## ADDENDUM #1

Reference: Guard Station – Camp Williams  
Utah National Guard  
DFCM Project No. 06286480

ADDENDUM #1  
NEW GUARDHOUSE  
UTAH NATIONAL GUARD  
CAMP W.G. WILLIAMS, UTAH  
PROJECT # 06286480

**HANDRAIL DET.**

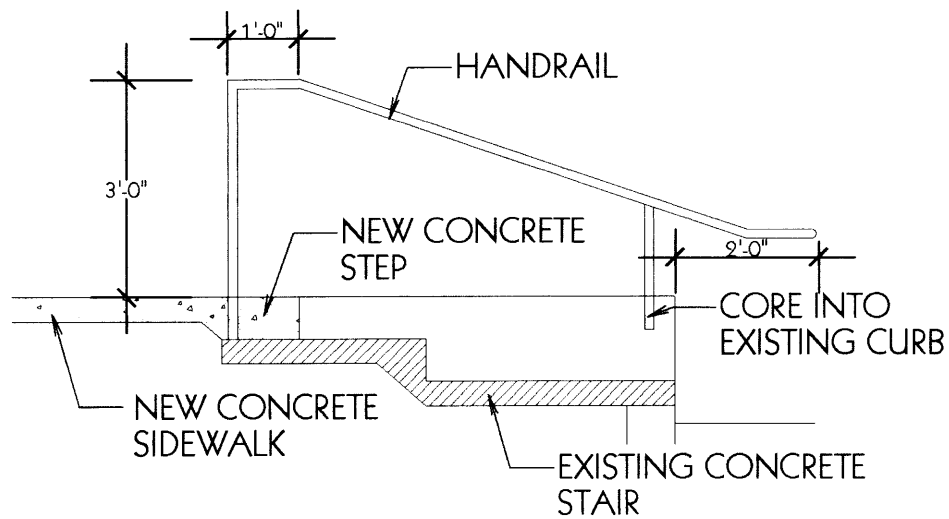
**Replace detail 6/AE101 with attached revised detail 6r1/AE101**

**Change keyed Note #7 on AE 101 to read: New handrail on both sides of stair – See 6/AE101**

**AD01-E01**

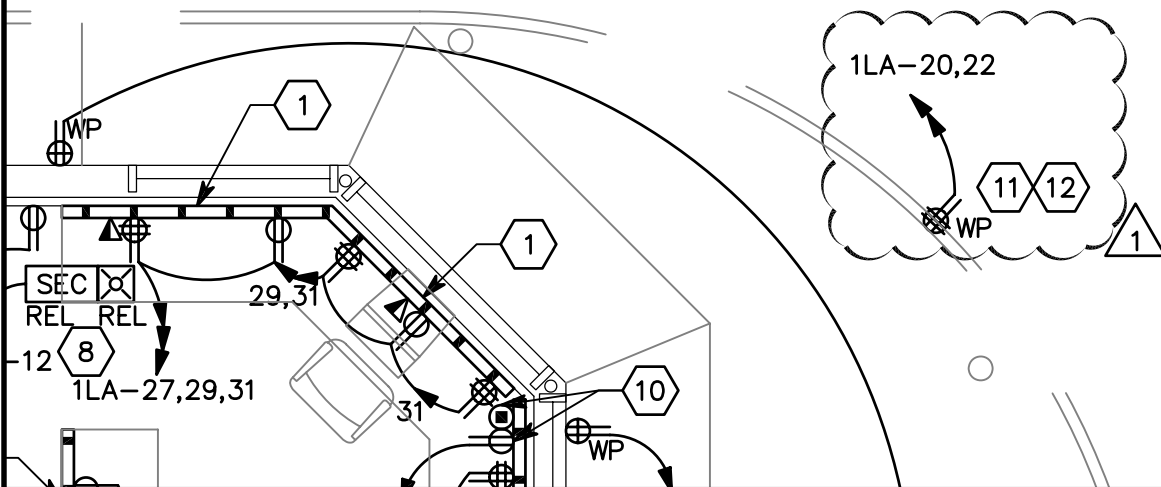
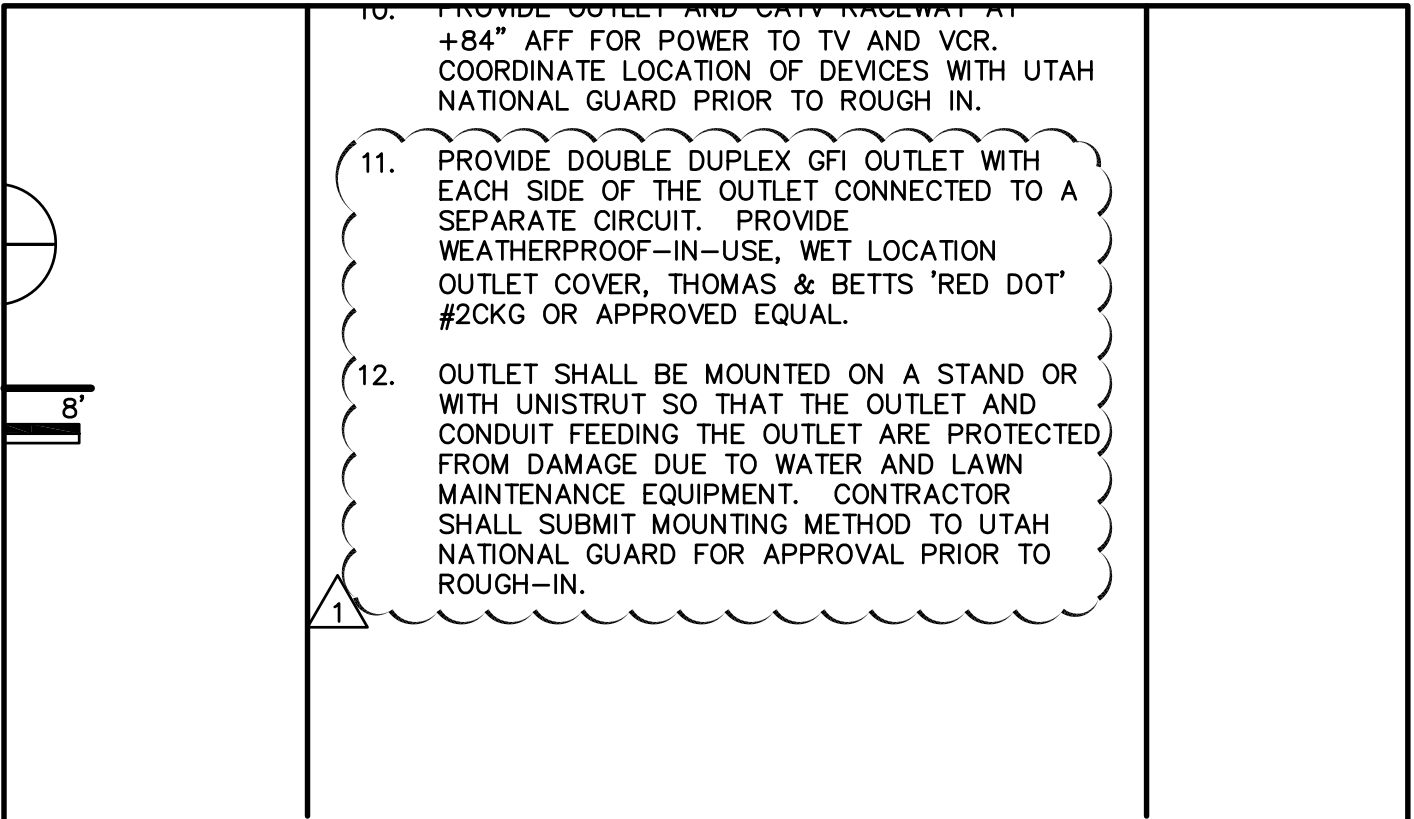
**Revise electrical per attached sketches AD01-E01 and AD01-E02 to add an outlet at the location of the work lights**
